SAF Axles with KNORR Disc Brakes with the SAF identification SBK 2243, \bar{A} Disc: 430mm

In the course of product development, the KNORR disc brake with the SAF identification SBK 2243 has been revised.

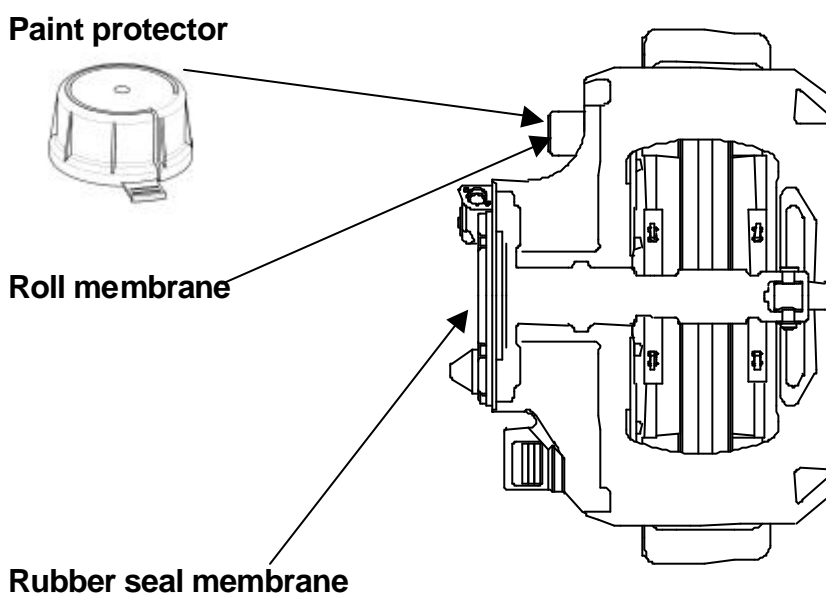
When painting the suspension/axle components protect the rubber seal membrane and the roll membrane with appropriate cover. These parts must be kept free from paint to prevent damage to the rubber material.

Attention: Is there a paint protector on the roll membrane it has to be removed before operation.

When fitting the brake chamber the rubber seal membrane **can remain** on this position, **must not be removed** from the matting surface caliper/brake chamber. This will not have a critical effect to the caliper actuation.
